June 24, 2026

SUBJECT: Opposition to Phoenix Area FAA Modernization Project; Request to Revise and Re-Publish the Draft Environmental Assessment and Delay IFP Scheduled Publication

On behalf of the City of Phoenix Aviation Department and the City's Airport System (PHX, DVT and GYR), thank you for the opportunity to provide comments on the proposed Phoenix Area Modernization Project ("Project") and Draft Environmental Assessment ("DEA"). The City commends the FAA for its commitment to improving our air transportation system through the development of safer and more efficient airspace management strategies. The City further recognizes the positive steps FAA has taken over the last 10 years to enhance public participation in airspace design initiatives and the overall process inclusiveness and transparency the FAA now strives for.

a. SDL WF SIDS (All)

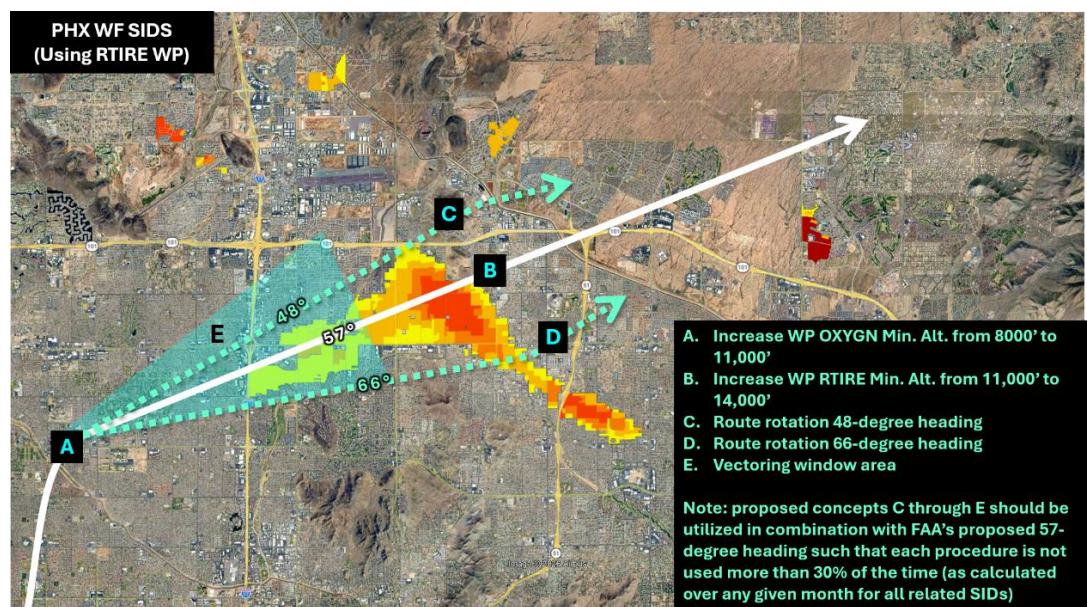
6. Produce a revised DEA that includes route alternatives and noise diffusion/dispersion programs by holding formal PBN working group meetings to analyze for flyability, environmental impact and consistency with the DEA purpose and need (ie, net benefit for reducing controller workload) the following proposed route modifications (ie, waypoint altitude minimum level increase), conceptual routes for noise dispersion/diffusion through route rotation programs and noise dispersion/diffusion through vectoring window programs:
